**HORIZONTAL DIRECTIONAL DRILL ANALYSIS  
SCHOOL HOUSE ROAD CROSSING  
PADEP SECTION 105 PERMIT NO.: E38-194  
PA-LE-0005.0000-RD-16  
(SPLP HDD No. S3-0091-16)**

This reanalysis of the horizontal directional drill (HDD) installation of a 16-inch diameter pipeline that traverses School House Road in South Londonderry Township, Lebanon County, Pennsylvania, is in accordance with the Stipulated Order issued under Environmental Hearing Board Docket No. 2017-009-L for HDDs listed on Exhibit 3 of the Stipulated Order. This HDD is number 12 on the list of HDDs included on Exhibit 3 of the Order.

**REVISED HORIZONTAL DIRECTIONAL DRILL DESIGN SUMMARY: 16-INCH**

Figure 2. Redesigned 16-Inch HDD Plan and Profile

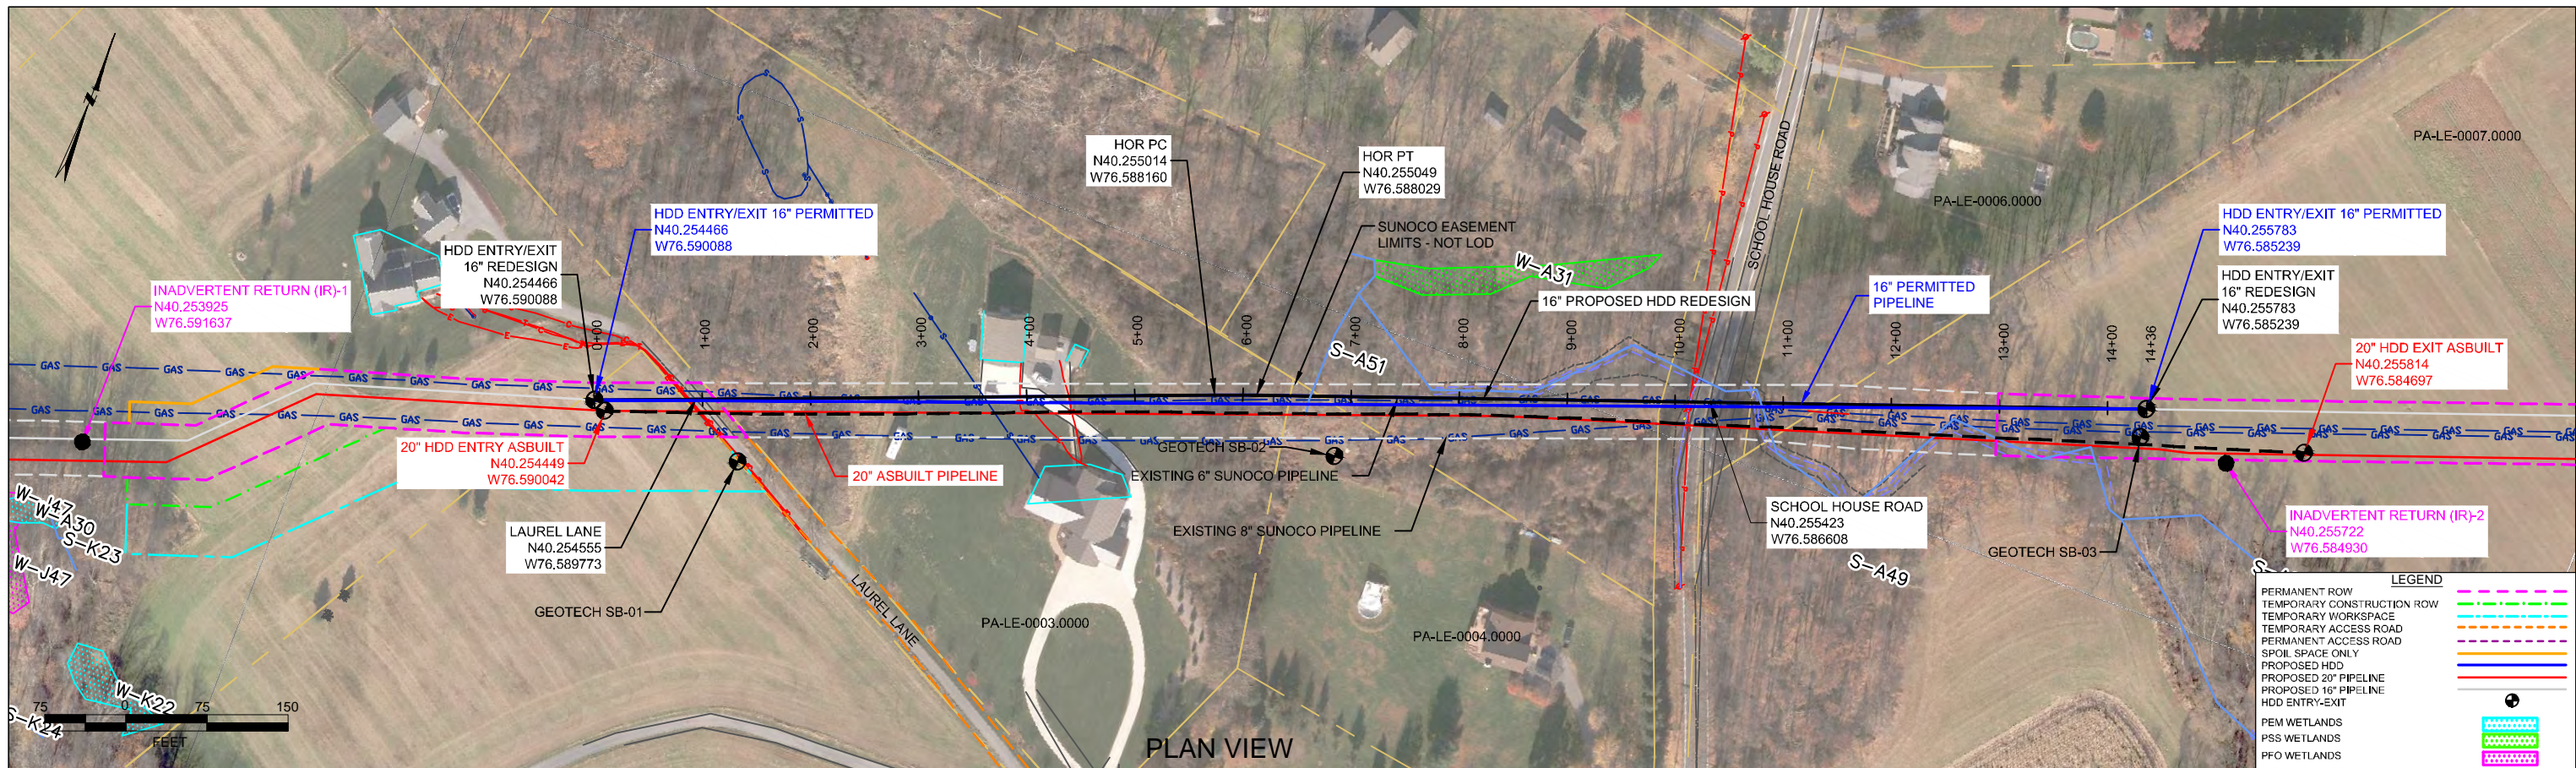
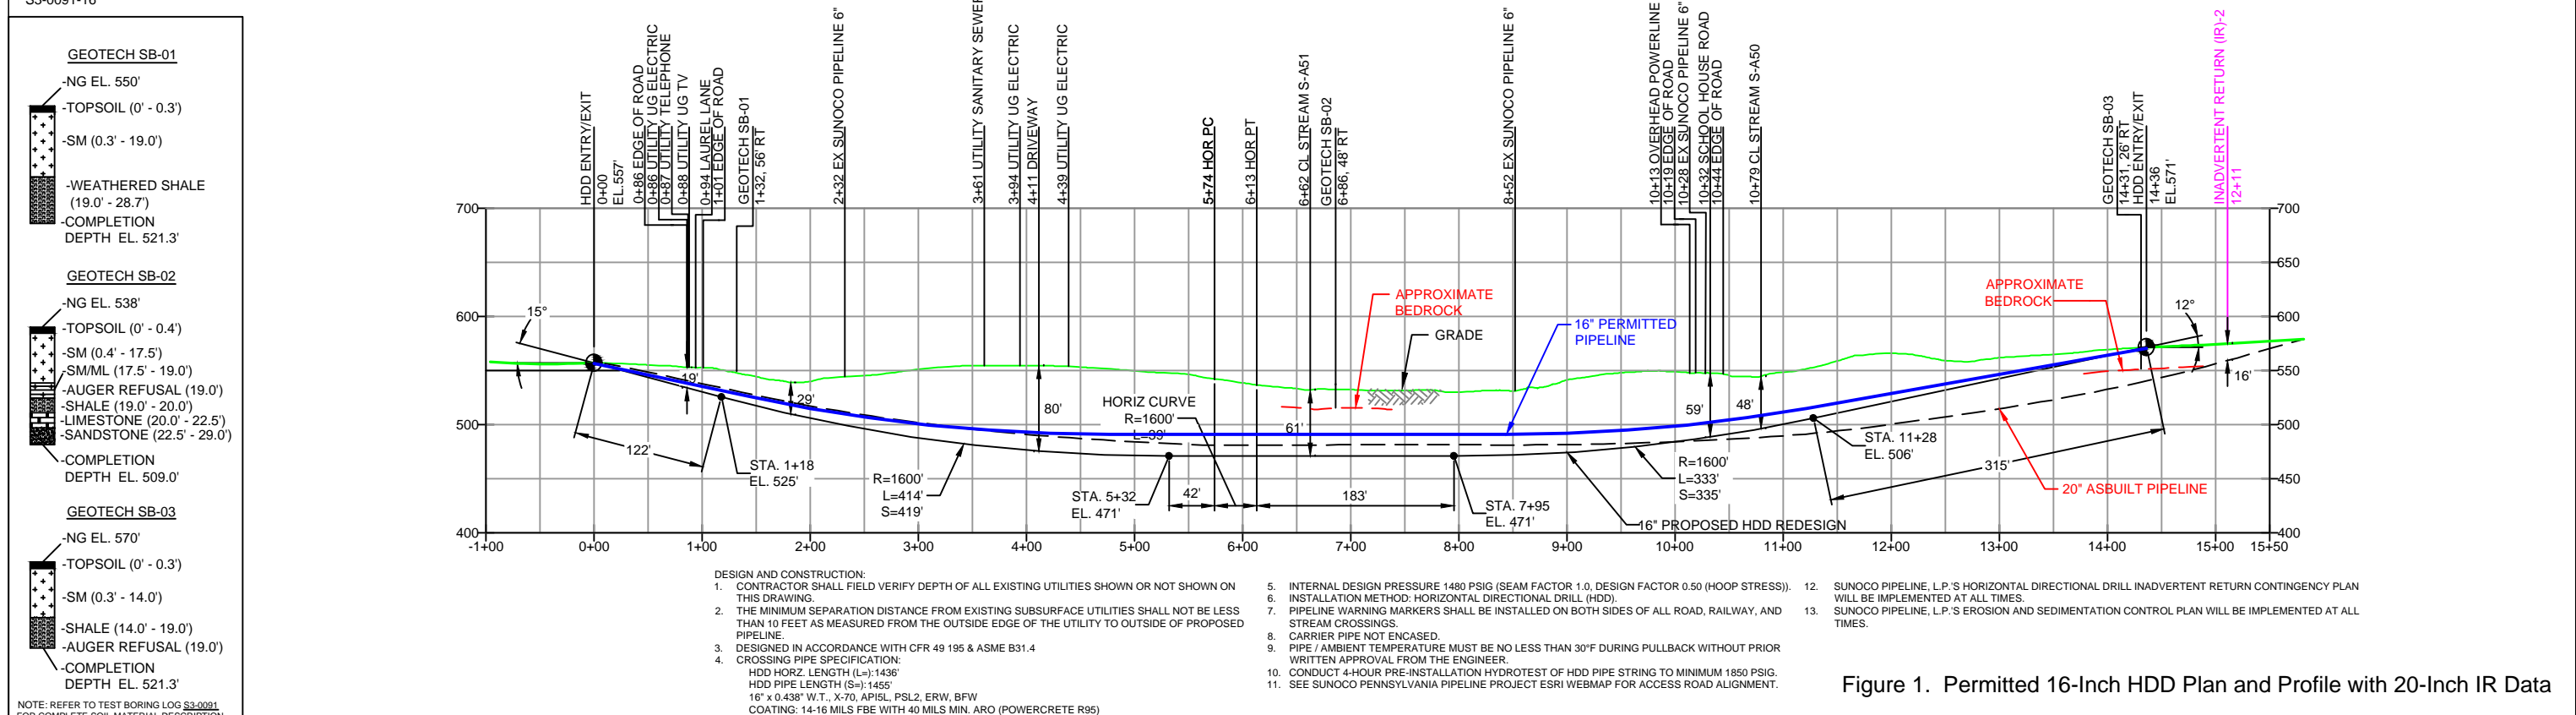
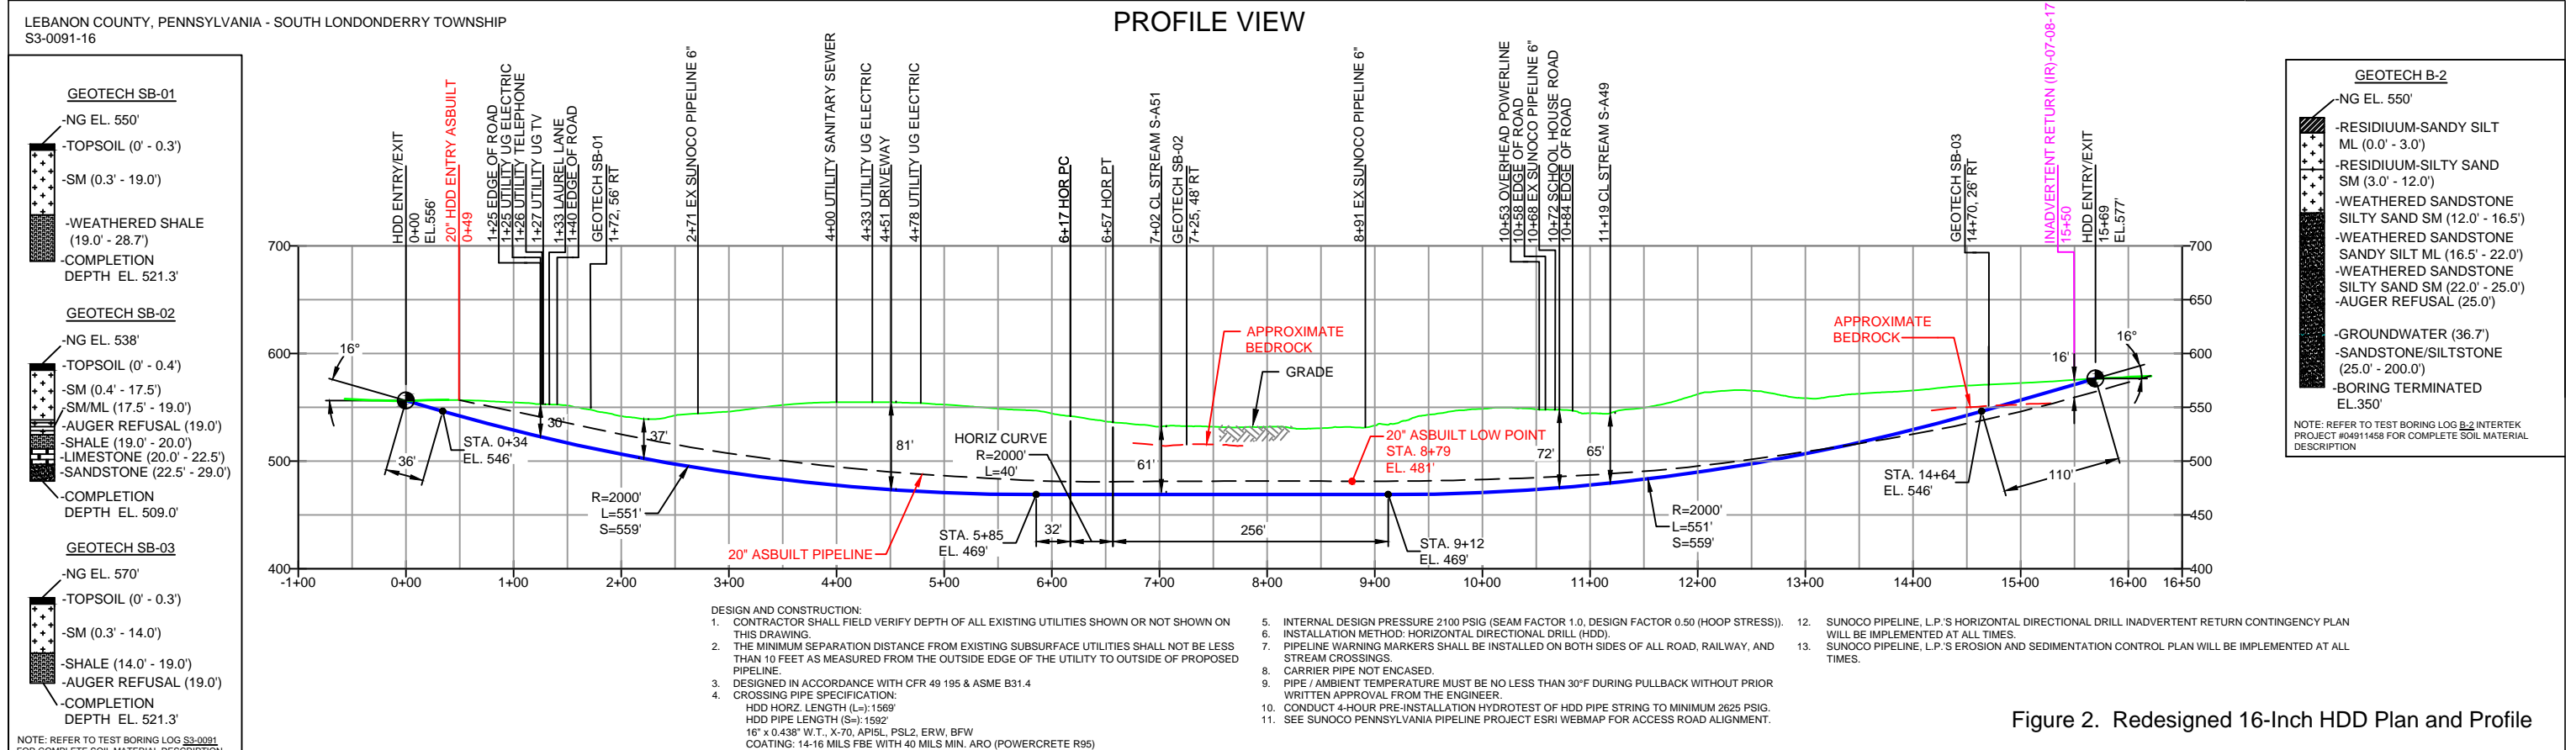
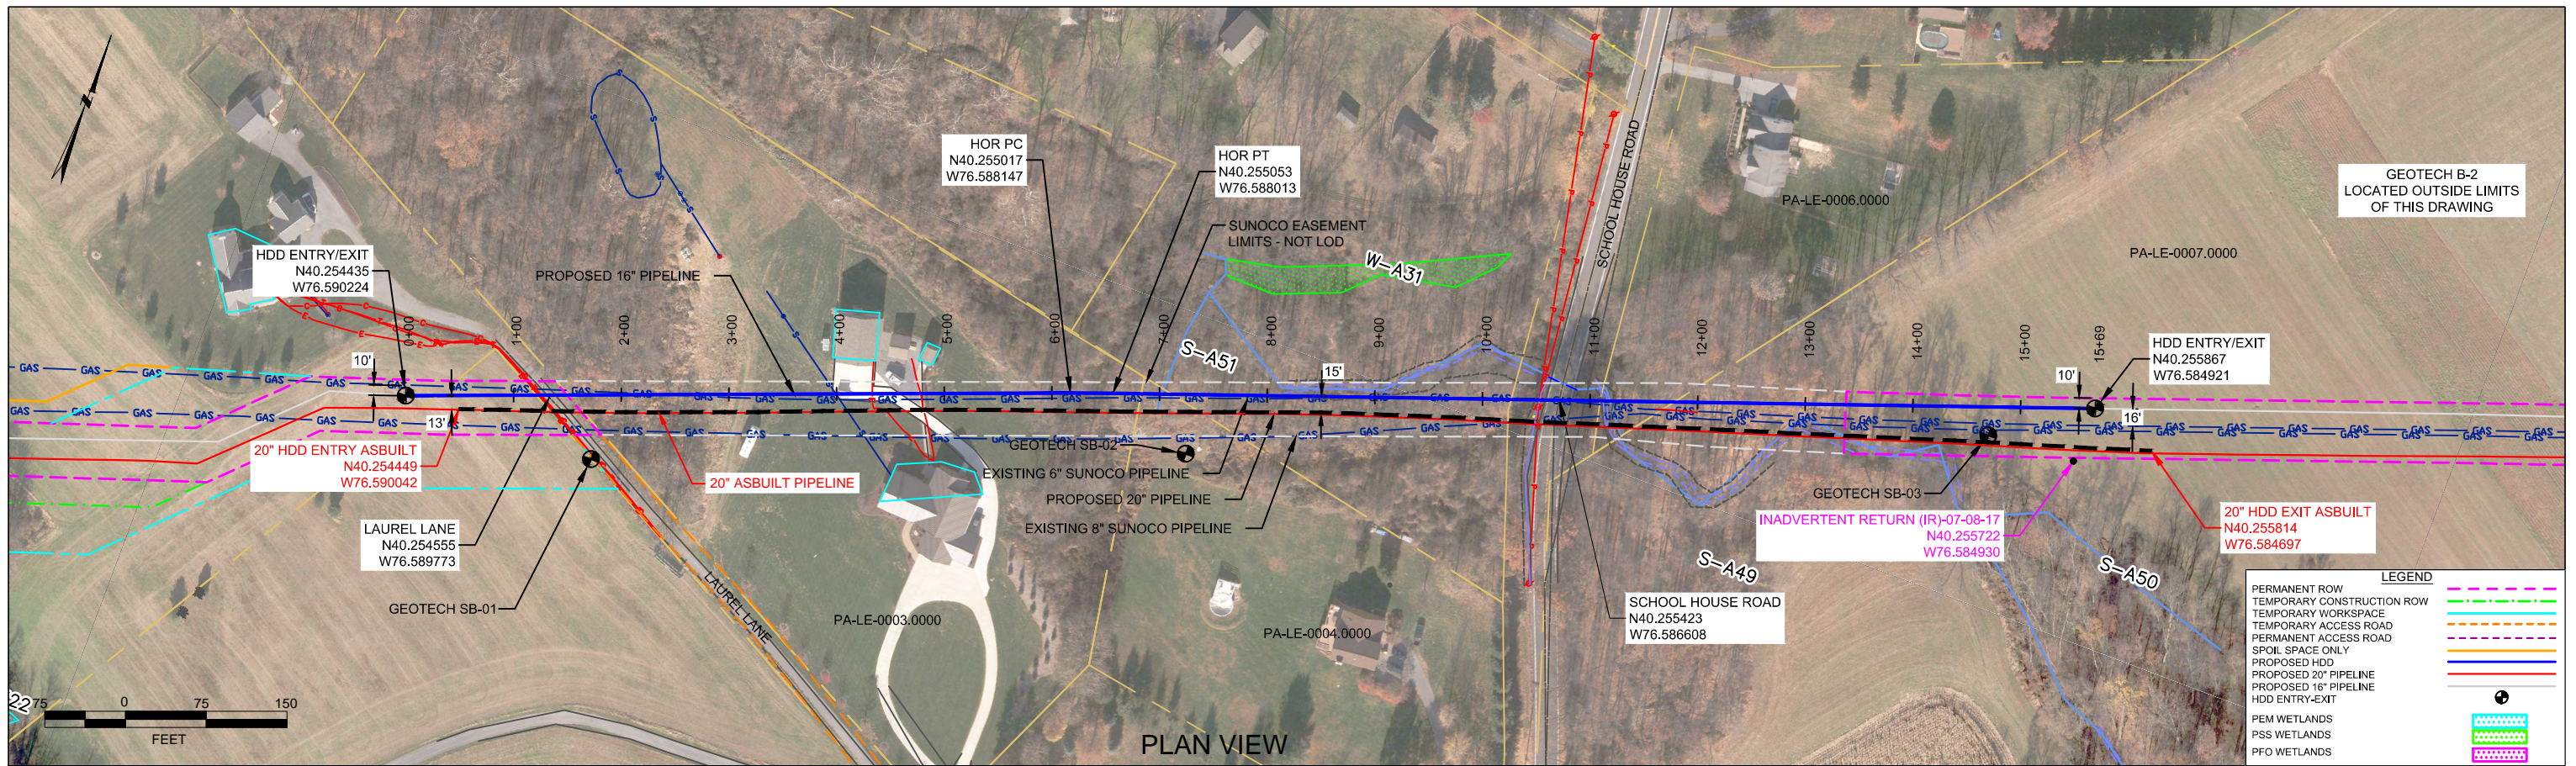
After review of the original HDD designs, geotechnical data, field reports related to the IR event that occurred during installation of the 20" pipeline, SPLP HDD specialists have redesigned this HDD. A summary of the redesign factors is provided below. The original and redesigned HDD plan and profile drawings are provided in Attachment 2.

As shown on Figure 2, the redesigned HDD extends the profile by 133 ft, increases the entry and exit angles, and adjusts the HDD profile deeper to minimize the risk of drilling fluid loss and IRs.

- Horizontal length: 1,569 ft
- Entry/Exit angle: 16 degrees
- Maximum Depth of cover: 81 ft
- Pipe design radius: 2,000 ft
